ADDENDUM NUMBER TWO (2)

<u>PROJECT</u>	<u>BIDS DUE</u>
GFA Project No: 19371	Date: May 28, 2020 Time: 11:00 AM Location: Peninsula Township 13235 Center Road Traverse City, MI 49686

Peninsula Township
Municipal Fire Station #3
Traverse City, MI

New Firestation for Peninsula Township Station #3

Item E-1: Refer to Sheet E3.1; Main Level Plan – Electrical (Revised Sheet E3.1 attached)

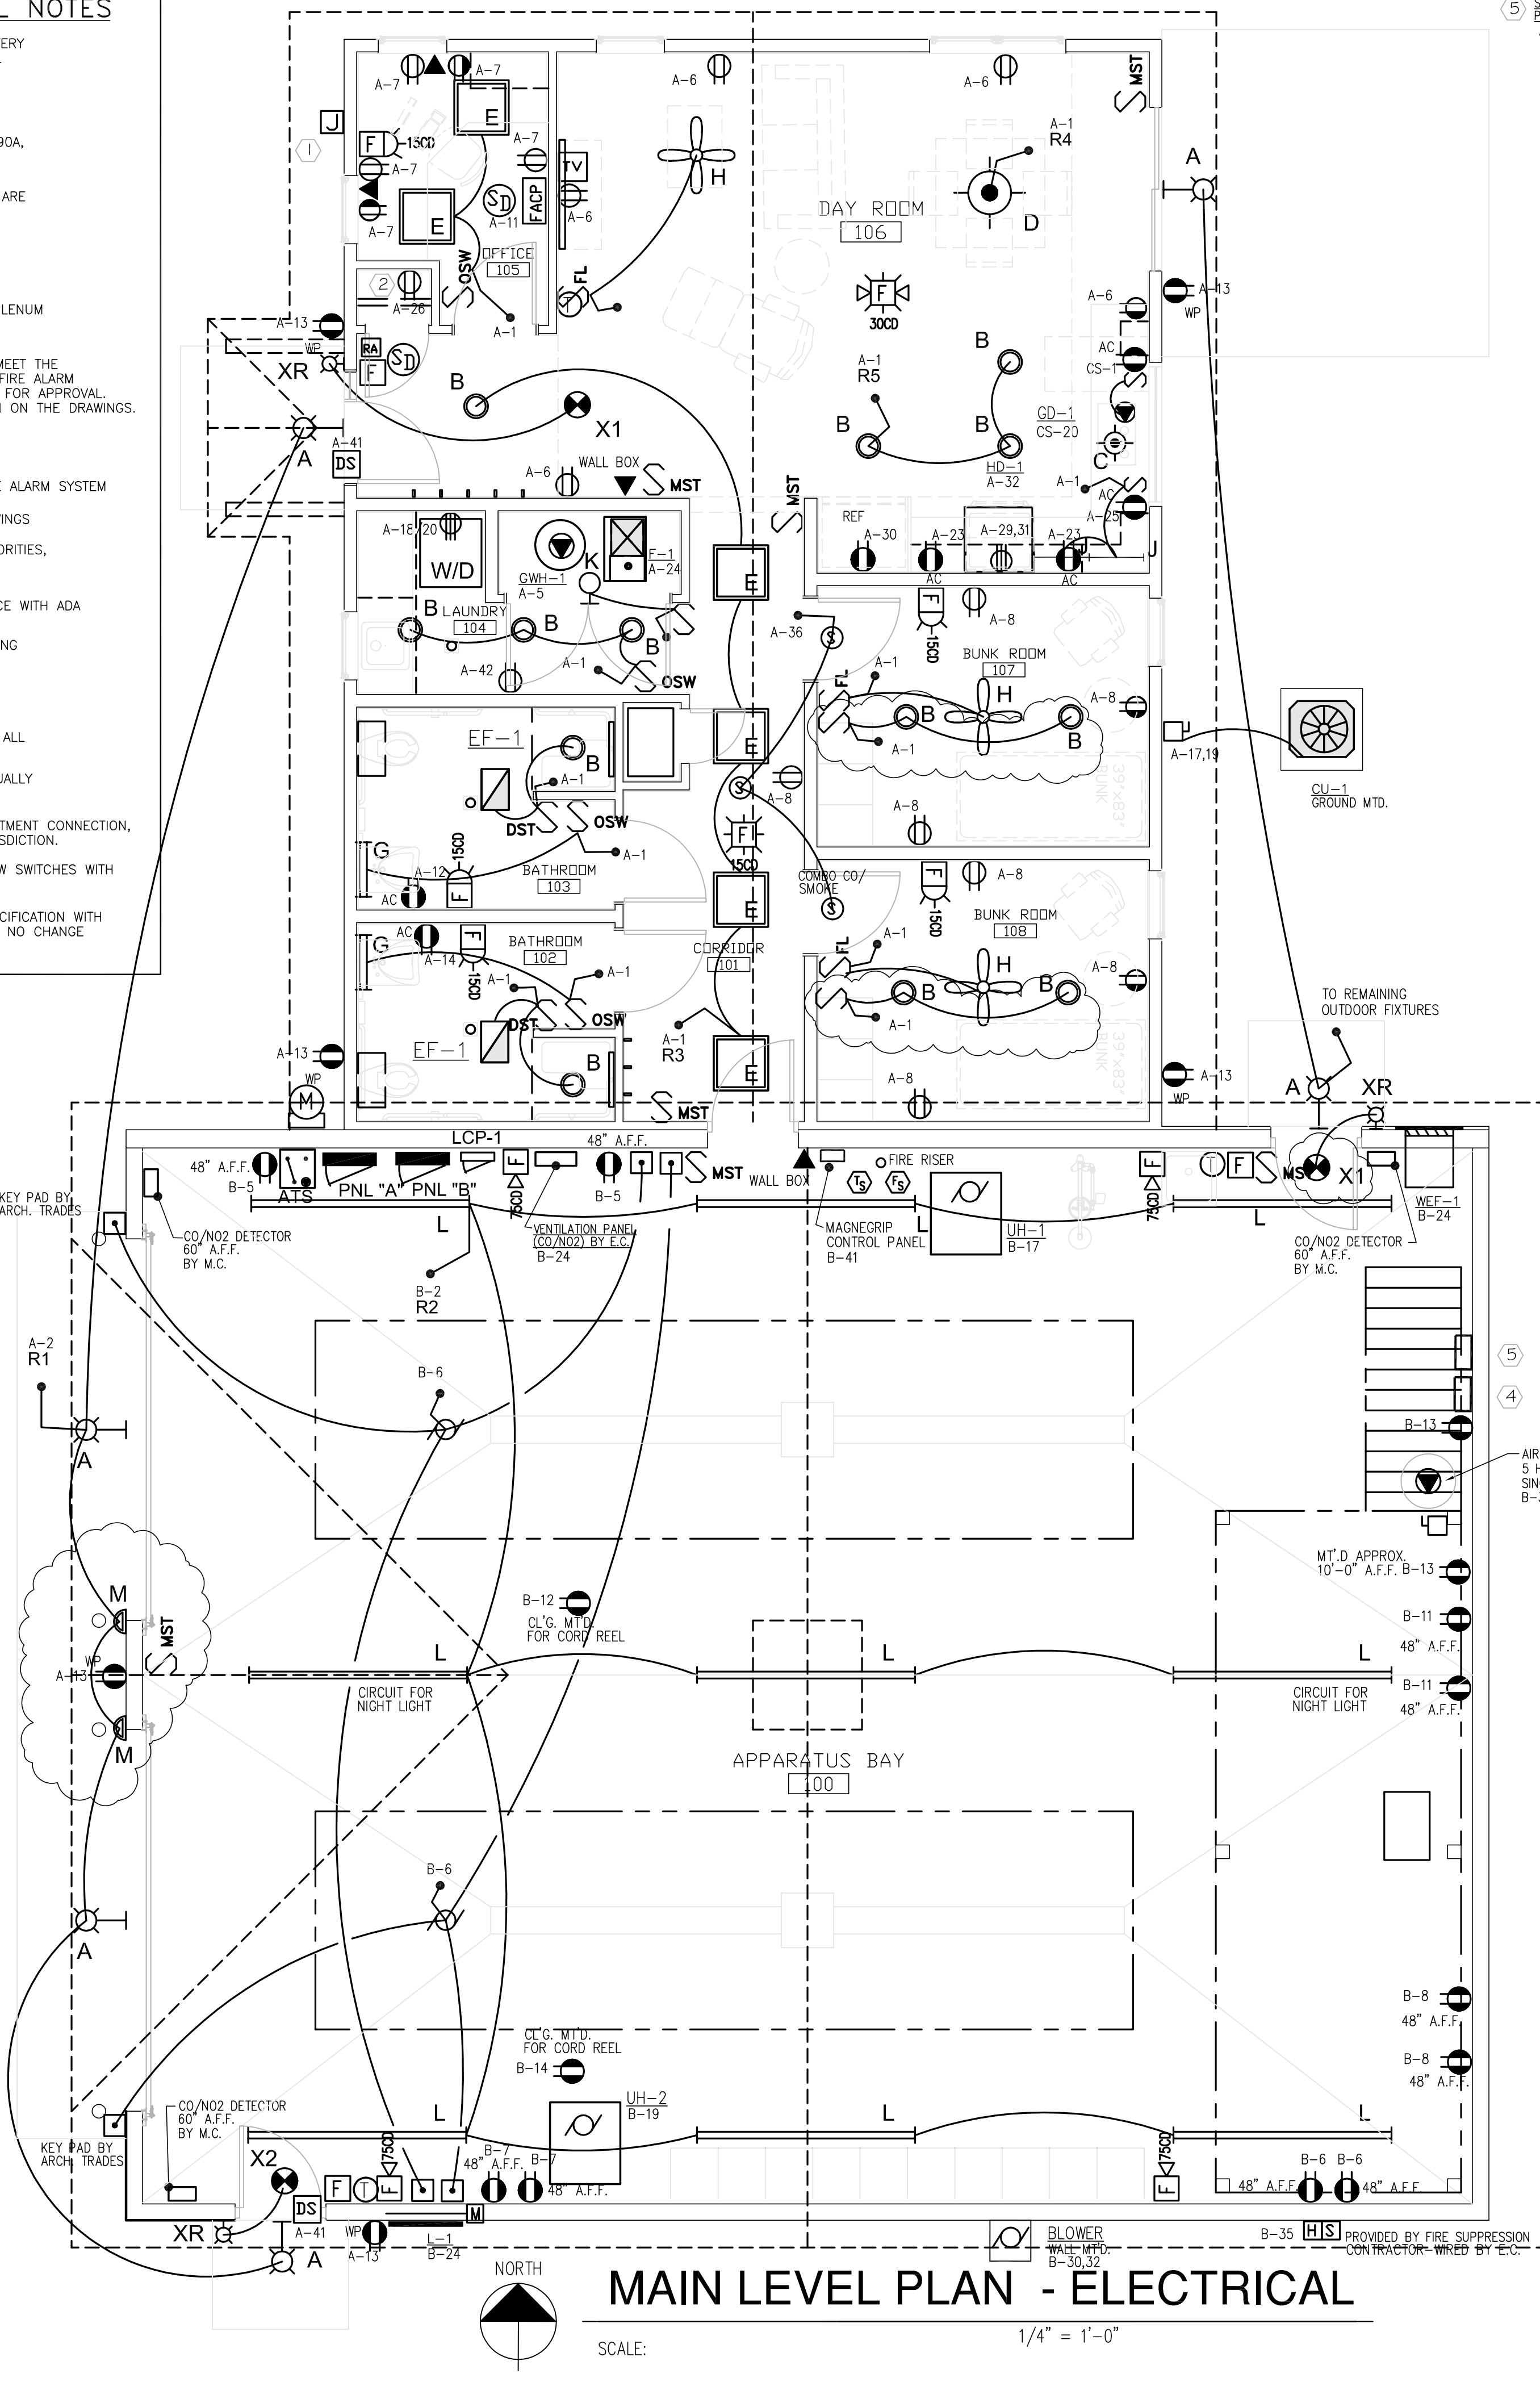
- a. Added two type “B” lights at Bunk Room 107 and Bunk Rom 108. With separate switch from fan.
- b. Refer to Lighting Fixture Schedule: Provide \$450.00 allowance for each Ceiling Fan “H”.
- c. Added two type “M” fixtures above garage door to illuminate signage.
